Attn: David Auster – Planner
Submission to DA2021/0973 – 116 Beatrice Street, Balgowlah Heights

Re: Letter of Objection to Development Application 2021 / 0973 for alterations and additions to a dwelling house including a swimming pool at 116 Beatrice Street, Balgowlah Heights NSW 2093

Existing roof to be replaced – not shown to be demolished

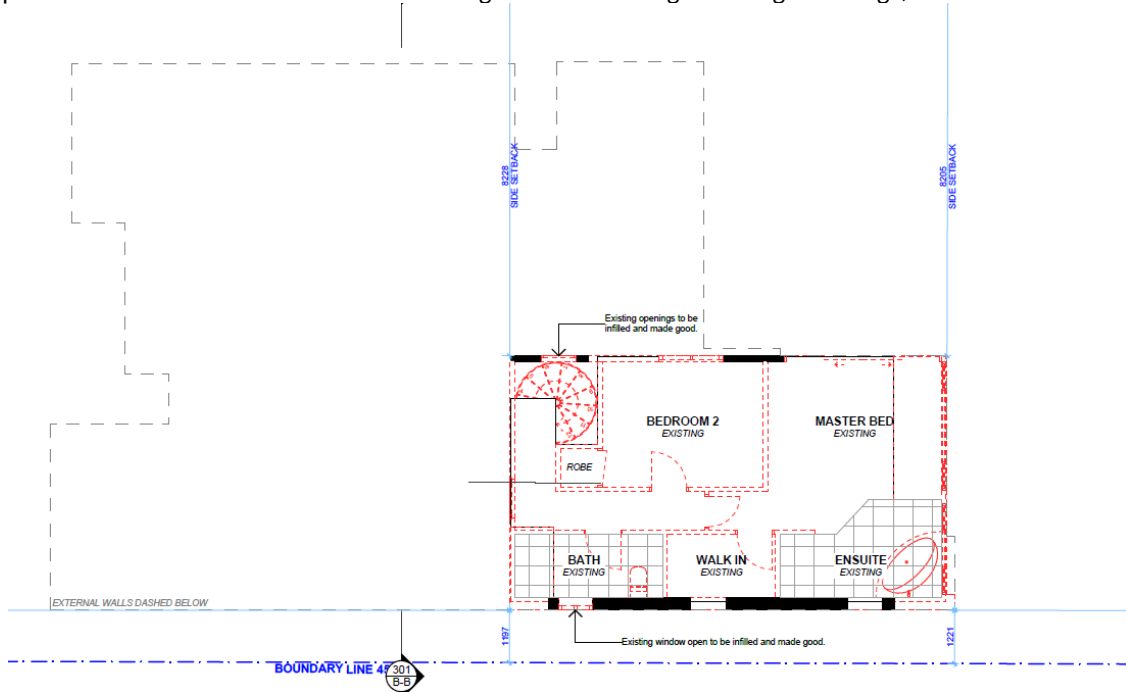
A snapshot of the site analysis shows the extent of the demolition works proposed. It is also important to factor in the increase to the building footprint and the non-compliances proposed which will have a detrimental impact to my client's property to the south.

It is also noted that the demolition plans are not consistent and don't include the full works to be completed on the site. It is noted that more than 50% of the dwelling will be demolished, and the whole roof will be replaced.

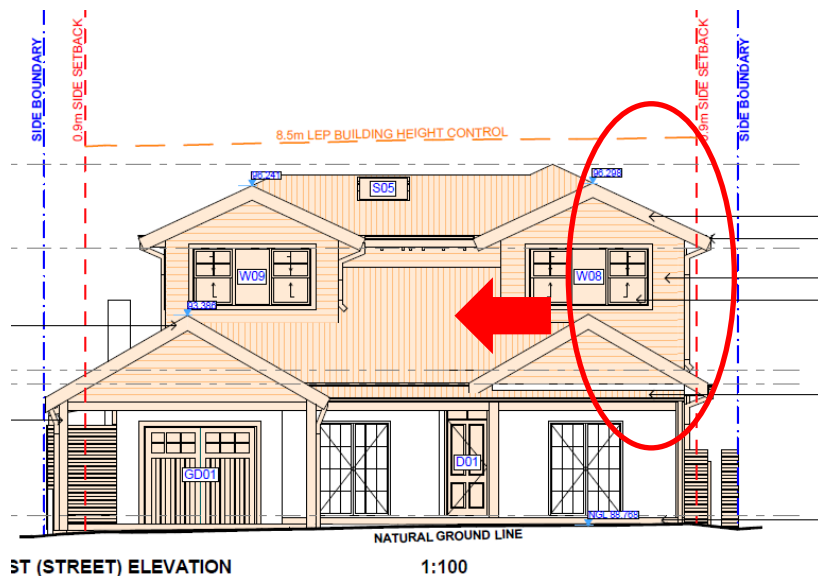
In particular, the demolition works proposed for the first floor (shown below) do not warrant the retainment as alterations and additions and should be adequately addressed to meet the relevant MDCP controls, in particular the required side setbacks and consistent rear alignment with neighbouring dwellings, as a new build.

It is noted that the first floor could easily comply with the requirements of the side setbacks through a better design, which would reduce the impacts to 114 Beatrice Street.

The above west elevation shows that the entire first floor could be reduced or shifted to the north to comply with MDCP. There is no valid or acceptable reason for Council to approve the proposed works which have a detrimental impact to my client's property to the south.

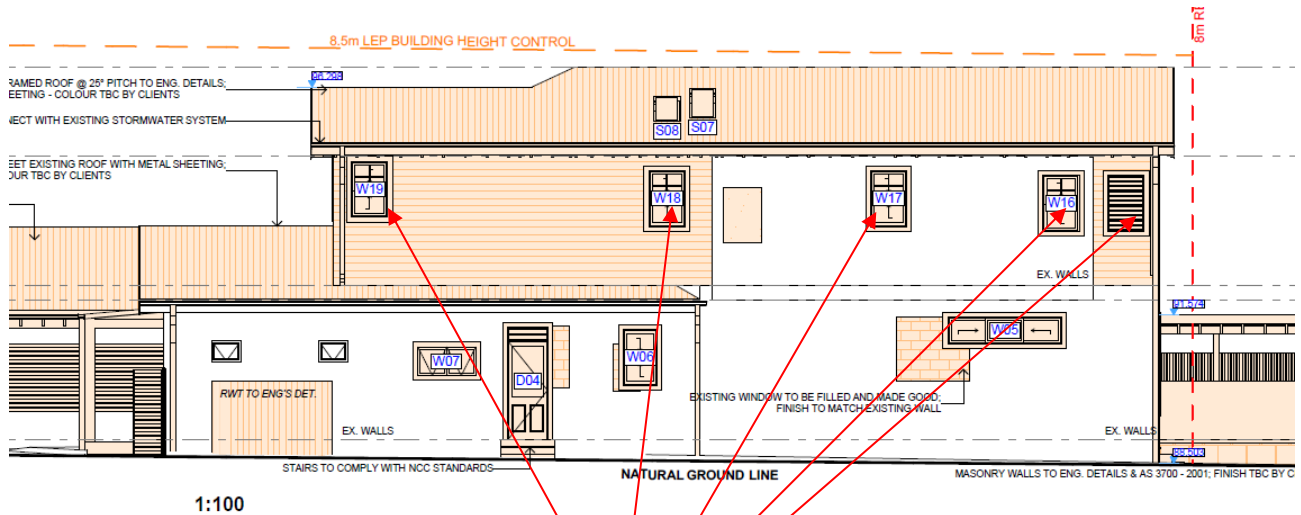
The existing dwelling house at 116 Beatrice Street, currently has one window on the first-floor southern elevation. The proposal now includes four (4) new windows and a balcony which will directly look into the private open space, and the swimming pool of my client's property.

The four new windows and balcony

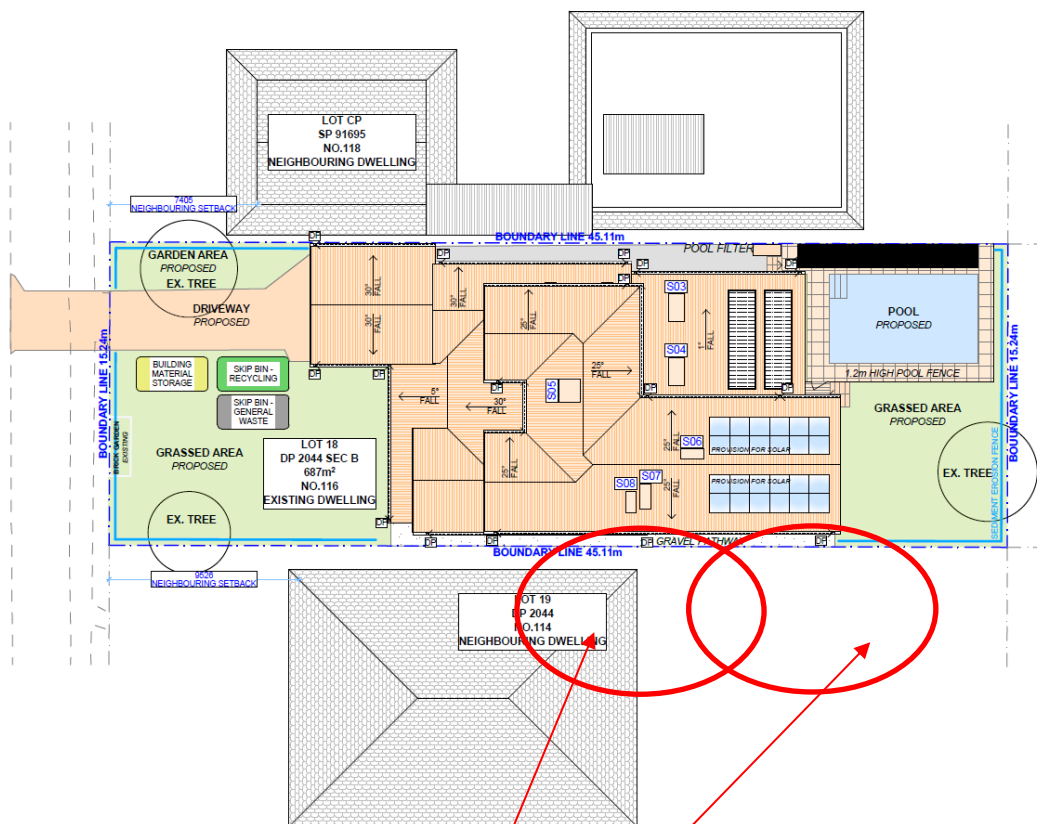
It is noted that the side setbacks don't comply, and the four new windows on the first floor are openable, not fixed, not frosted, not high sill and look directly into our private open space and swimming pool. The proposal includes two skylights for the bathroom and ensuite, therefore the windows are not required. It is also noted that the floor level of the ground floor will also result in potential overlooking and privacy concerns through the placement of windows and the laundry door. The windows are within 3m of the side boundary and don't comply with Councils controls. The proposal clearly has major deficiencies and will have a detrimental impact to my clients.

direct overlooking of outdoor living areas. The images on the following pages and an excerpt of the south elevation and site plan show the loss of privacy through the proposed development.

Location of the four new windows and balcony which will look directly into the private outdoor open space of 114 Beatrice Street

It is noted that the proposal increases the lack of privacy through poor design. Increased and compliant setbacks, along with high sill, obscured windows would assist to limit the impact of the current privacy impacts.

Missing portion of the house

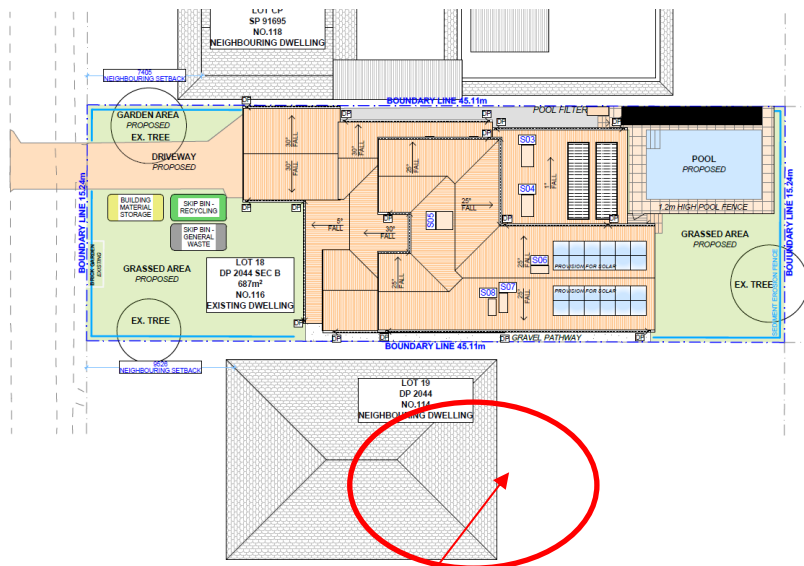
We request that the following additional shadow diagrams (including elevational shadow diagrams) for both winter solstice (21 June) and March and September equinox should be provided for a full assessment of impacts to our client's property. We also request that the plans are updated with the correct building footprint of 114 Beatrice Street, noting that the building footprint is not a square as shown on all the plans:

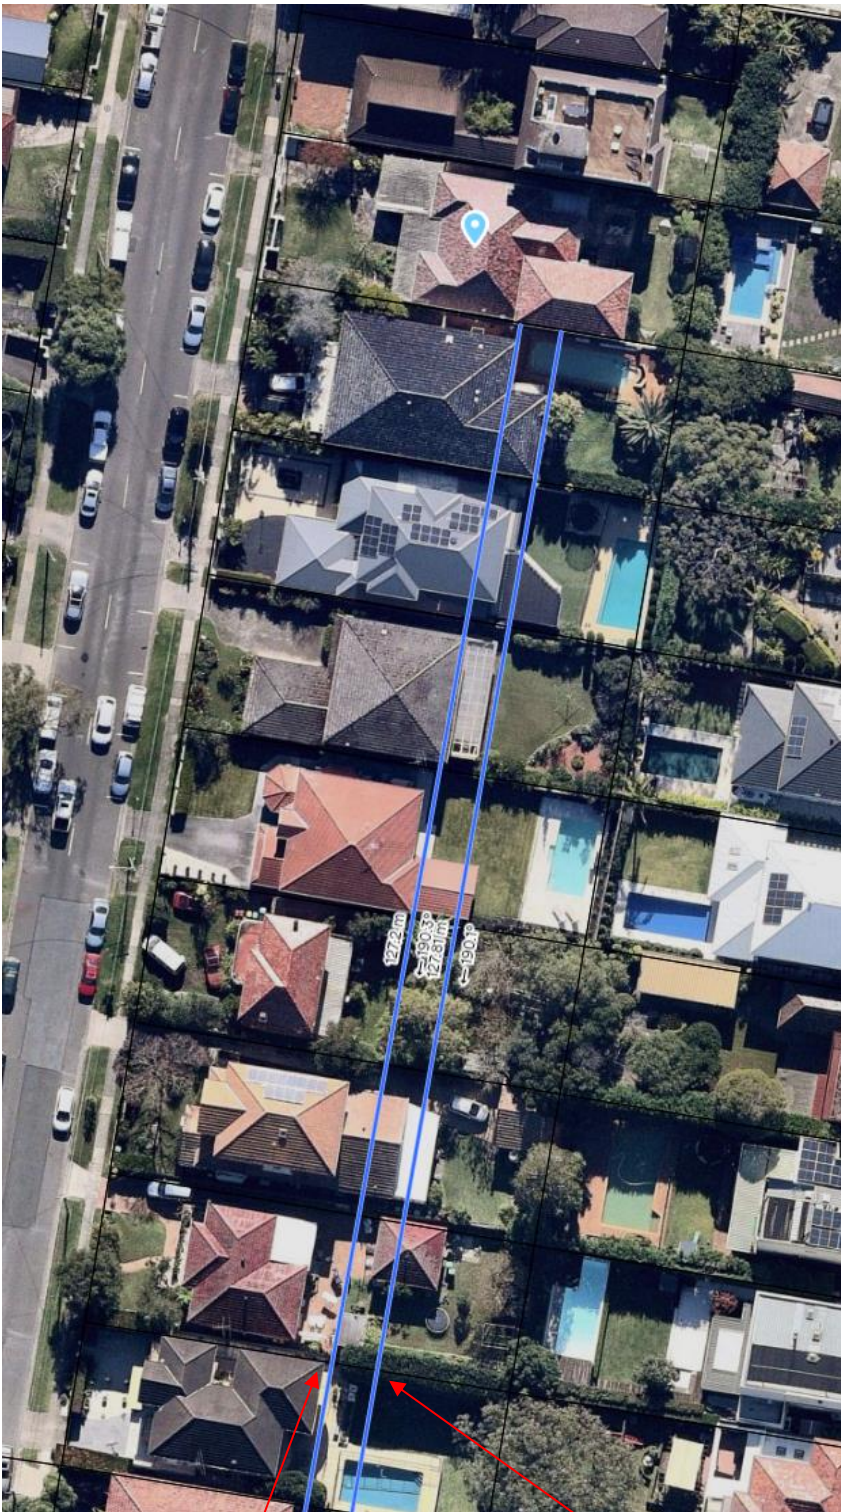
Notwithstanding the numerical control of 8m for the rear setback, it is considered that the proposal does not meet the requirement of 4.1.4.4 (d). The prevailing rear setbacks are highlighted on the next page with an average 13m ground floor rear setback and a 17m first-floor rear setback. If the proposal was to align with the prevailing pattern of setbacks and increase the side setback it would comply with overshadowing, visual privacy and view loss. It is noted that the properties to the north are not included as they relate to the B1 Neighbourhood Centre and an existing strata development with commercial uses.

Average Ground Floor Setback along Beatrice Street – 13m
Average First Floor Setback along Beatrice Street – 17m

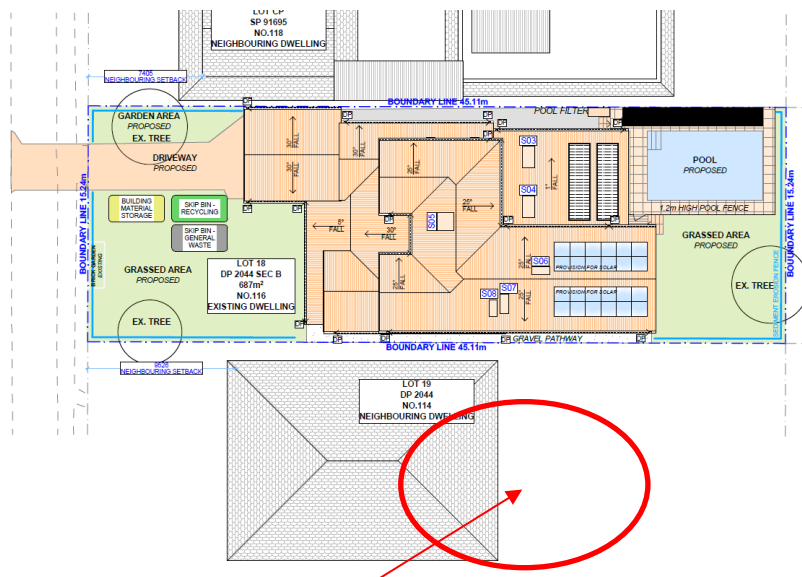
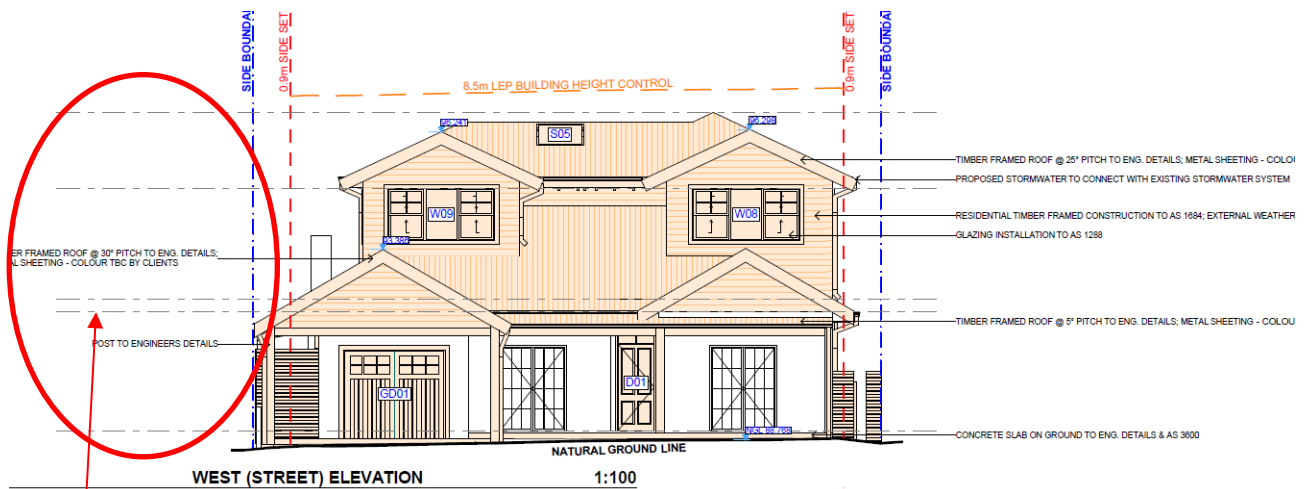
- Certification of Shadow Diagrams as per DA lodgement requirements
- Inadequate Architectural Plans - currently missing RLs on elevation plans, no roof plan, incorrect building footprints of adjoining neighbours shown (see below):

Missing portion of the house

No RLs provided
